**Economic and Social Council**Distr.: General  
4 July 2014

**World Forum for Harmonization of Vehicle Regulations****Working Party on Brakes and Running Gear****Seventy-eighth session**

**Motorcycle braking – Regulation No. 78****Proposal for amendments to Regulation No. 78 (Uniform provisions concerning the approval of vehicles of categories L<sub>1</sub>, L<sub>2</sub>, L<sub>3</sub>, L<sub>4</sub> and L<sub>5</sub> with regard to braking)****Submitted by the expert from International Motorcycles Manufacturers Association\***

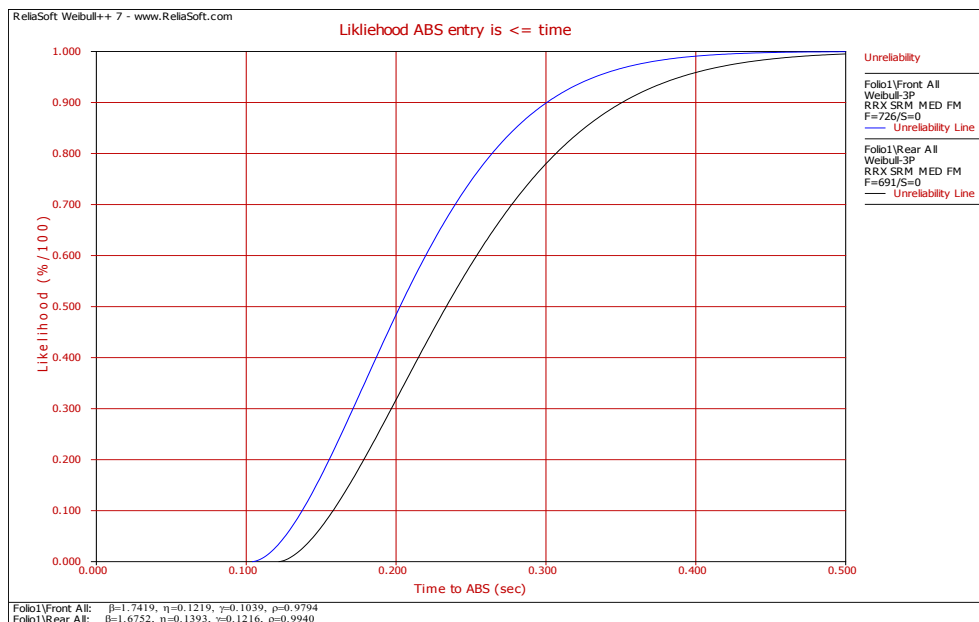
12. It has been noticed in testing that the brake application rate specified in section 4.9.5.1. can result in a large number of test failures. It can be seen in the chart below that the 0.2 second lower limit shows a failure rate is between 30 per cent and 50 per cent of the time.

13. By reducing the lower limit to 0.1 seconds, the test failure rate reduces to practically zero. Allowing the reduction tends to make the regulation more stringent by including a greater number of brake force application rates and eliminates restrictive test requirements.

The brake control actuation force is applied in ~~0.2~~ 0.1 – 0.5 seconds."
